# Town Council Meeting

**December 08, 2025 at 6:00 PM**

3. Consideration and Approval: **Hillside Groves Amenity Center - Final Site Plan Submittal**

4. Consideration and Approval: **Watermark - Final Subdivision Re-Submittal**

## TYPICAL CORNER LOT PLANTING

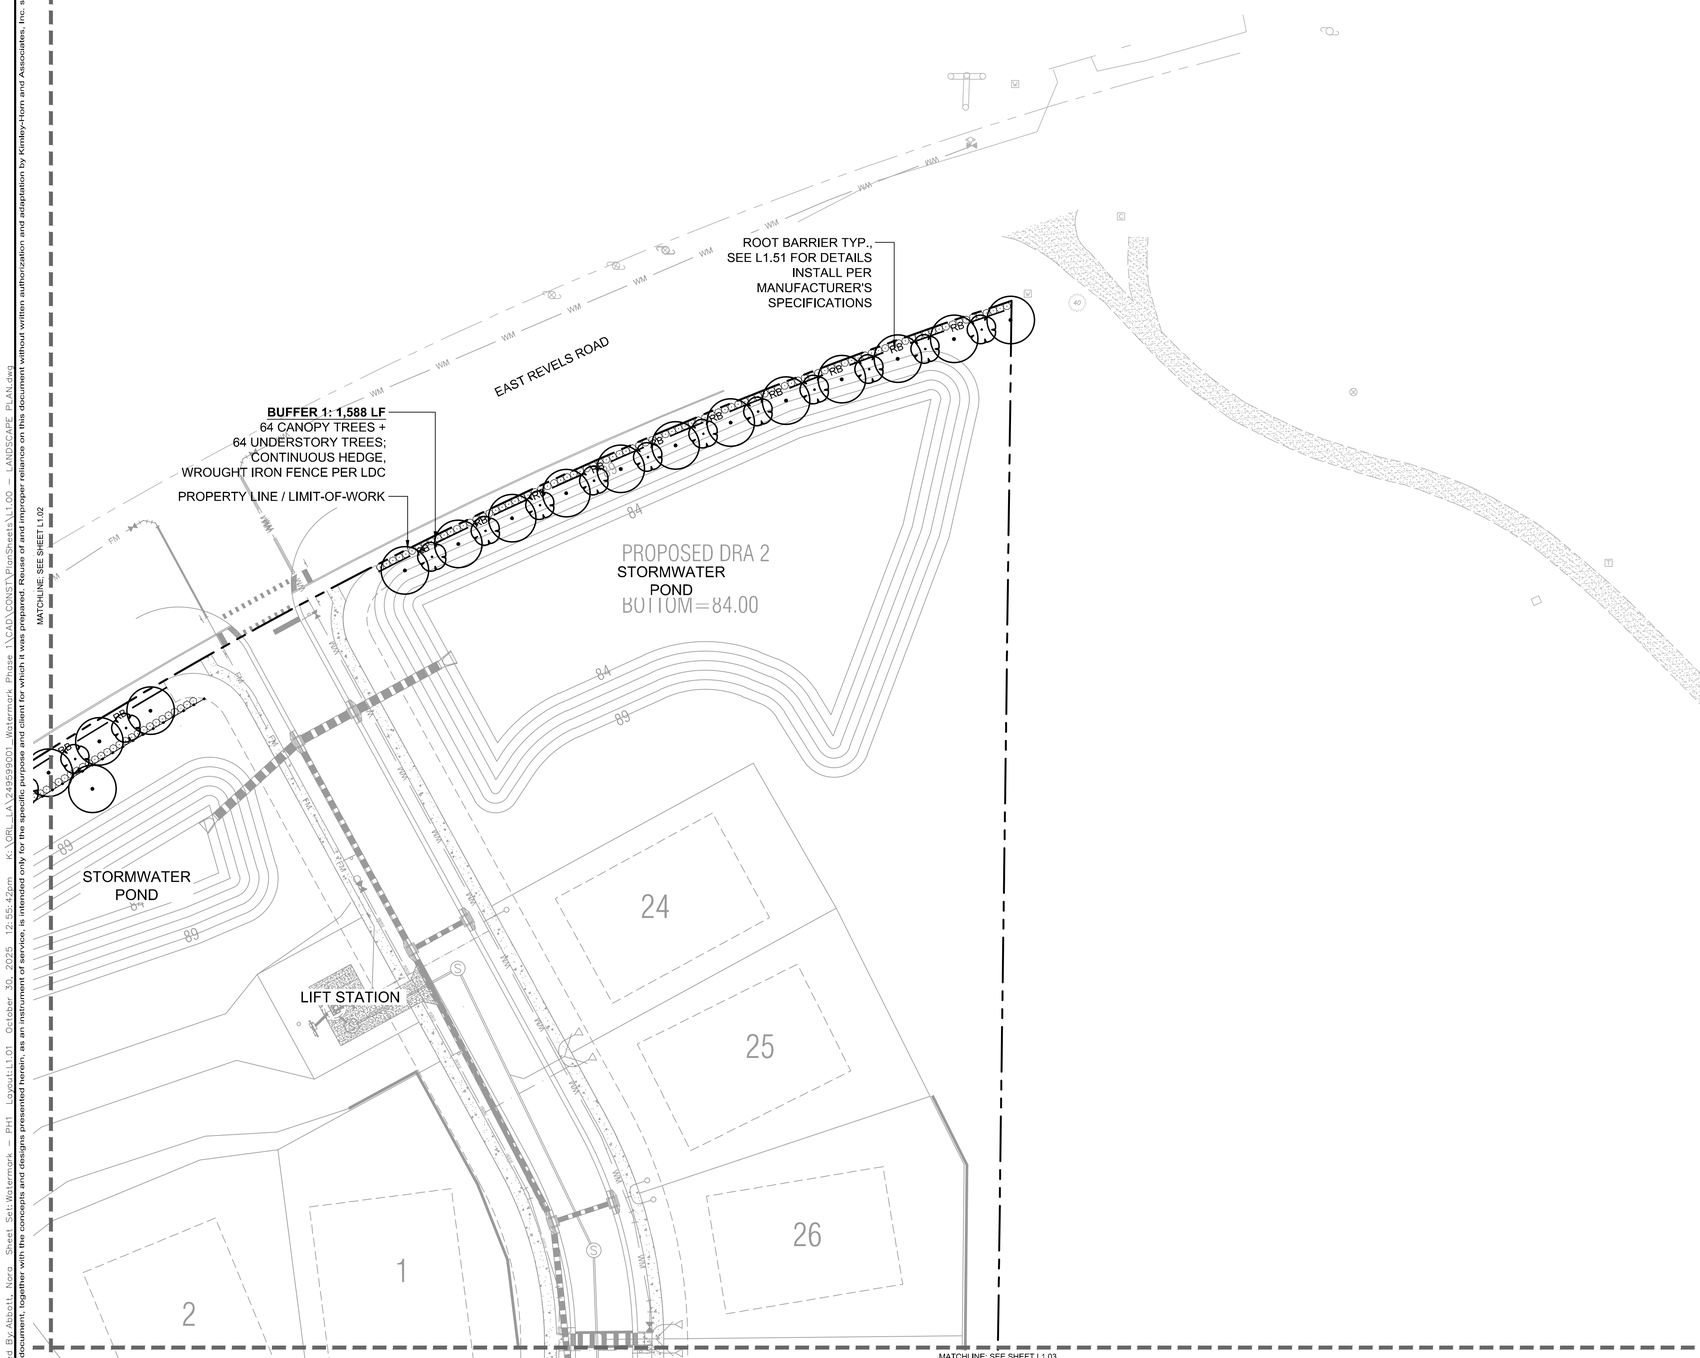
2. On Sheets L1.01 through L1.10, the typical corner lot planting needs to show an additional understory tree.

**Response: One additional understory tree has been added to the typical corner lot planting exhibit, please see sheets L1.01-L1.10 for updates.**

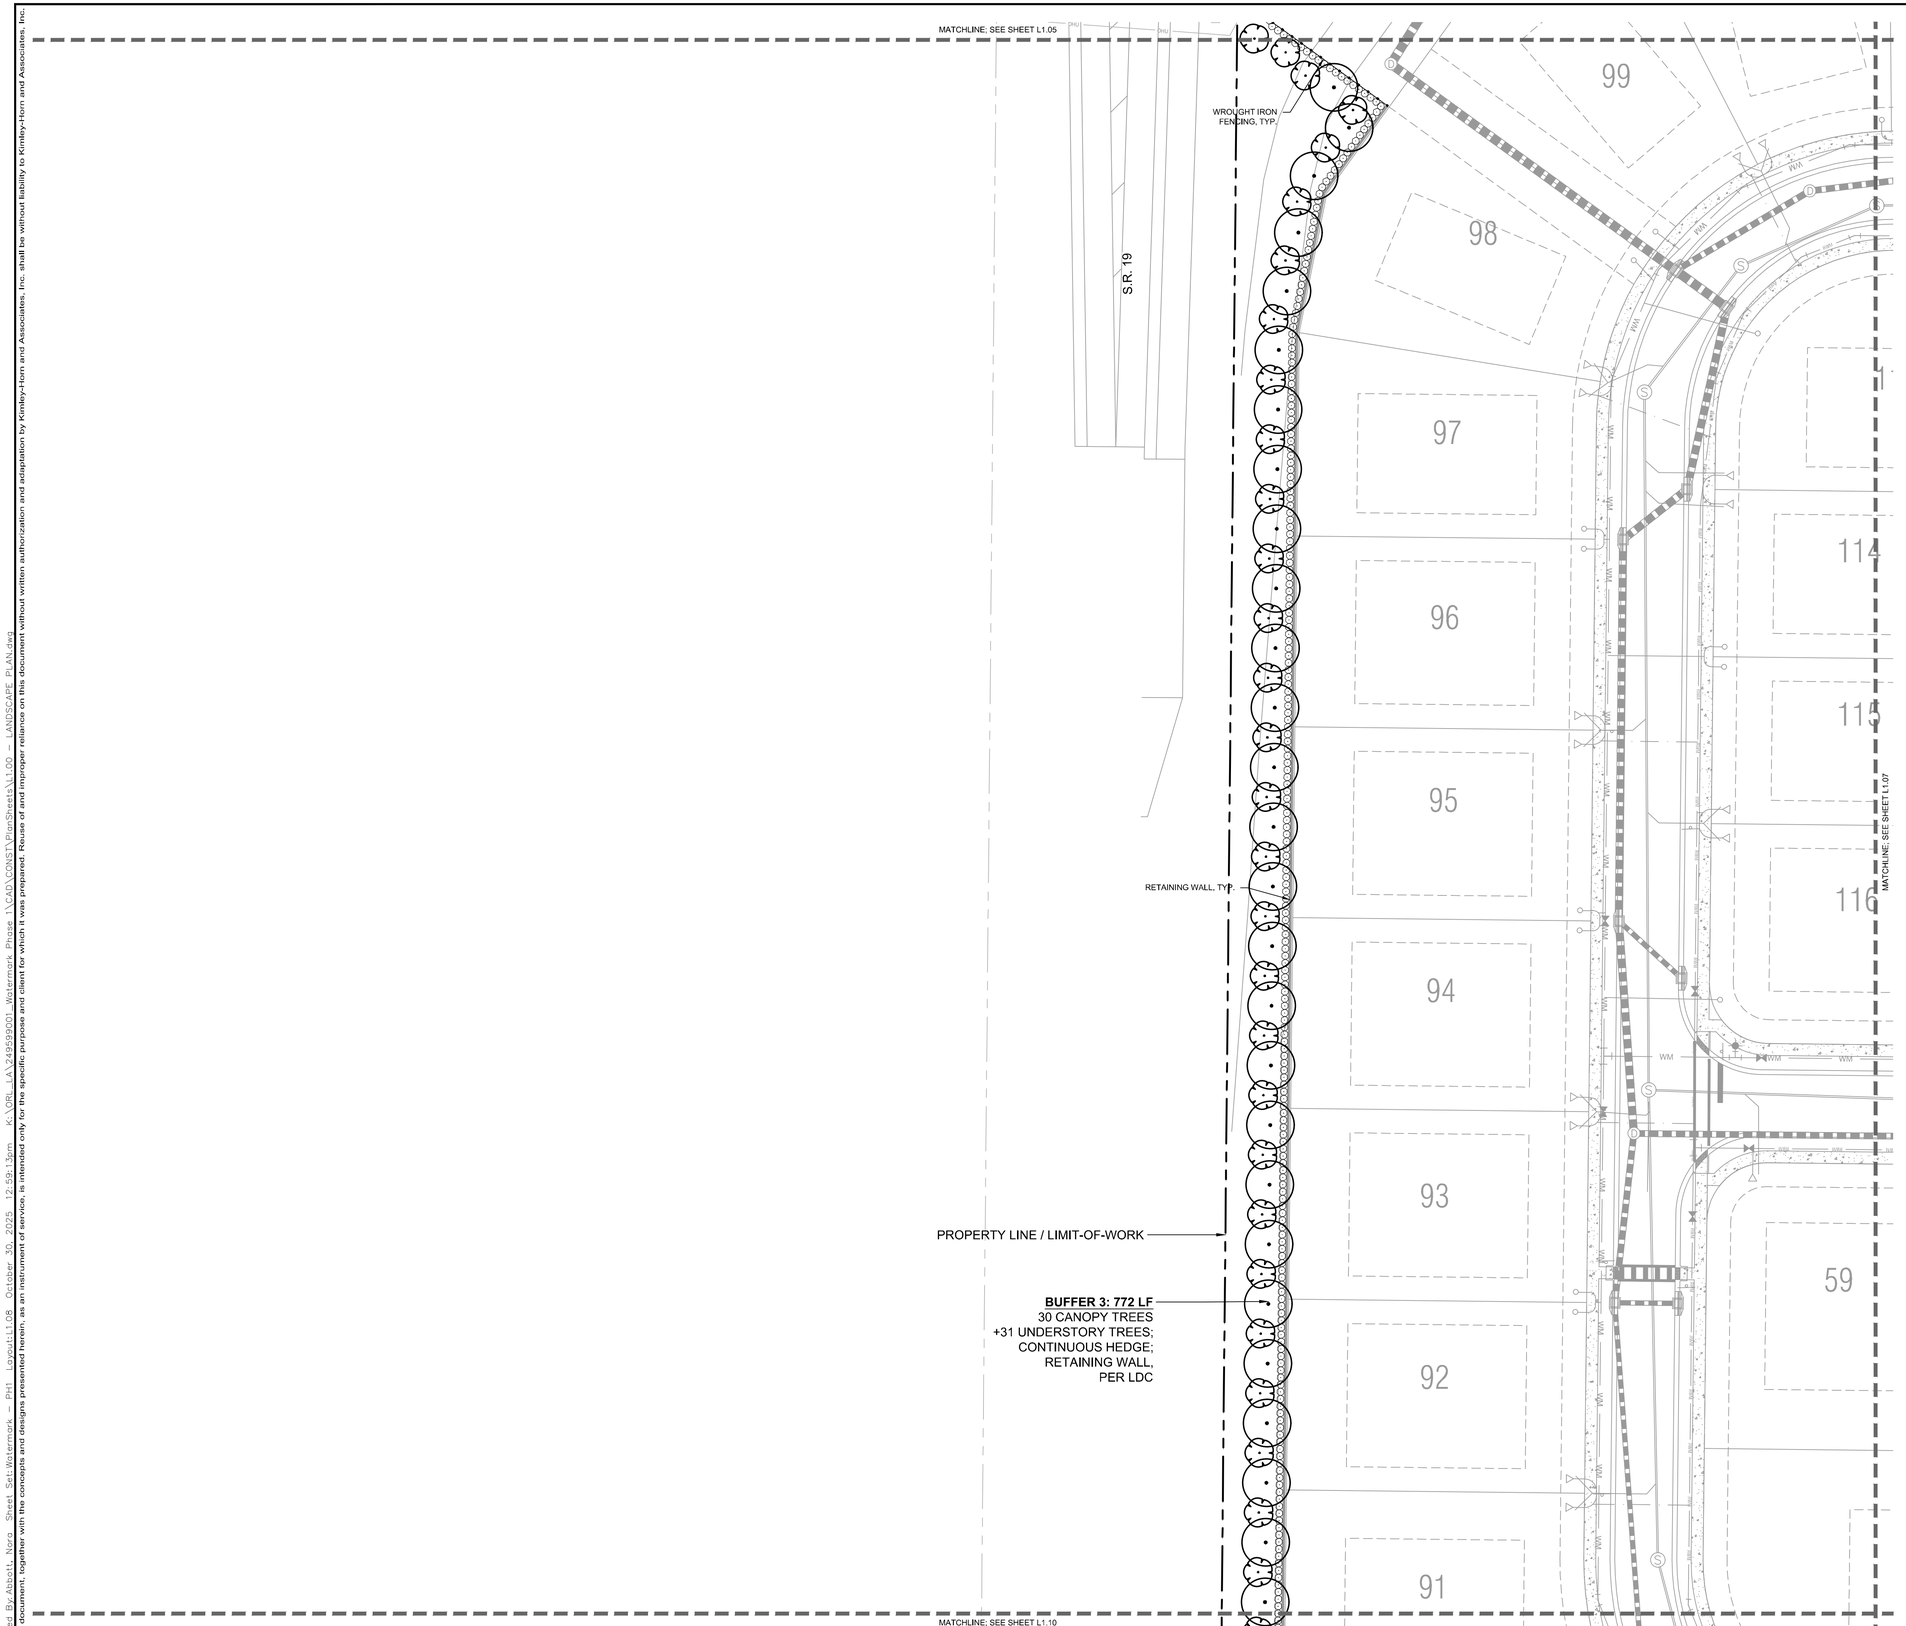
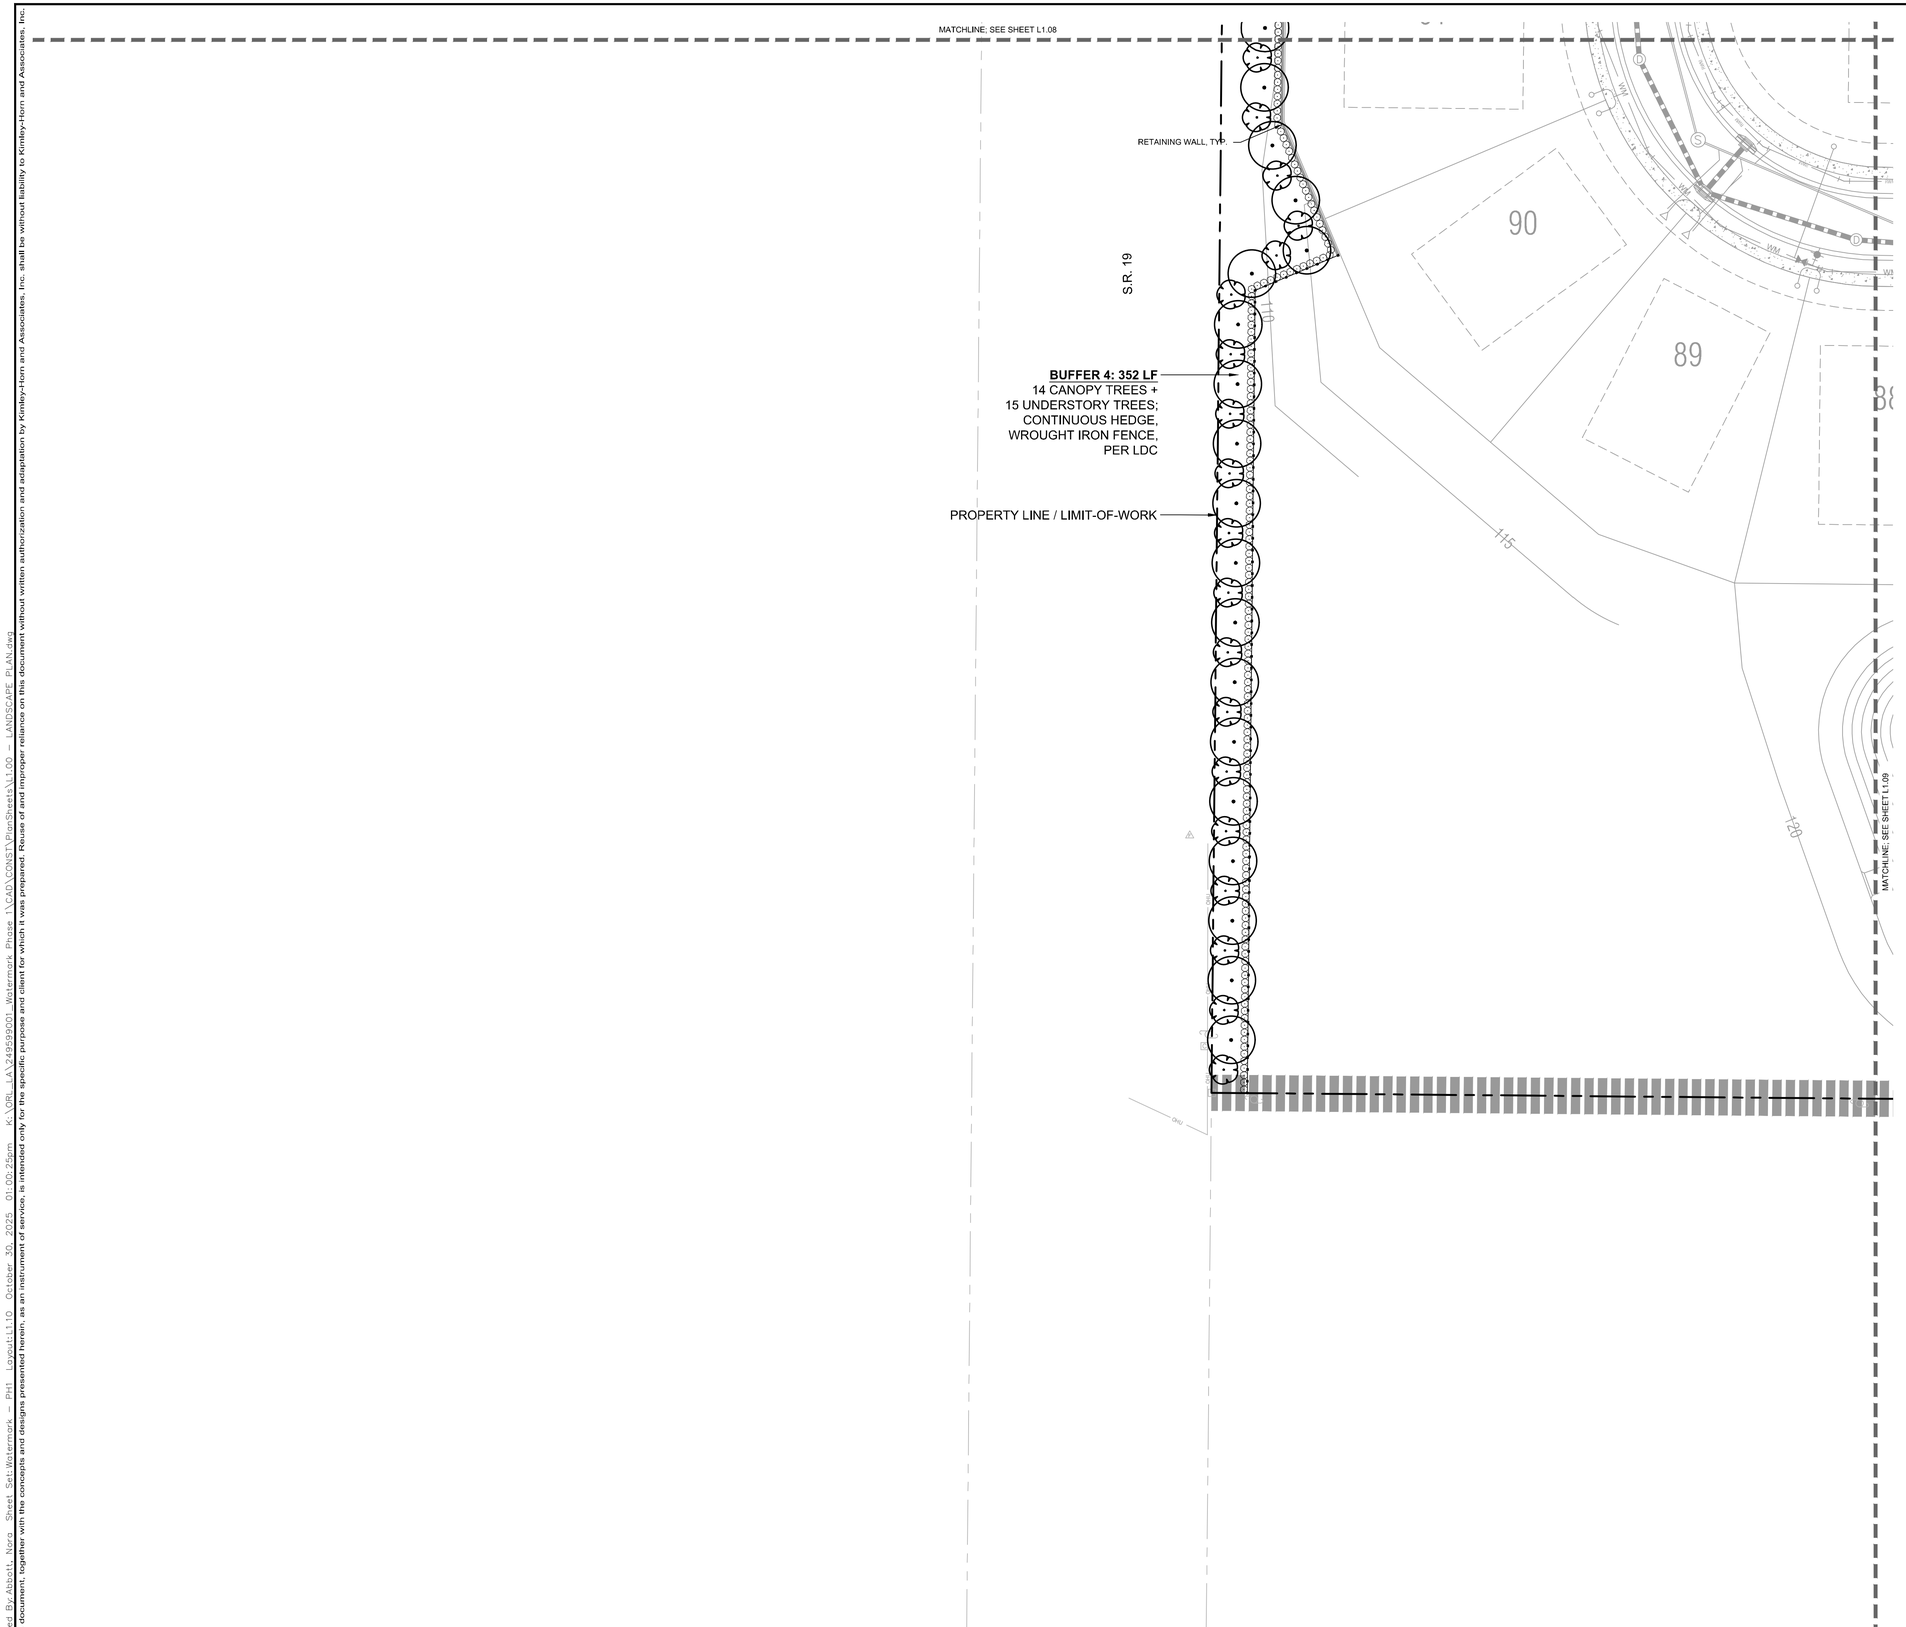
3. L1.08 through L1.10 and L2.08 through L2.10 need to be revised to show a wall per LDC requirements 7.02.01(B)(2) since these areas are not next to a stormwater pond.
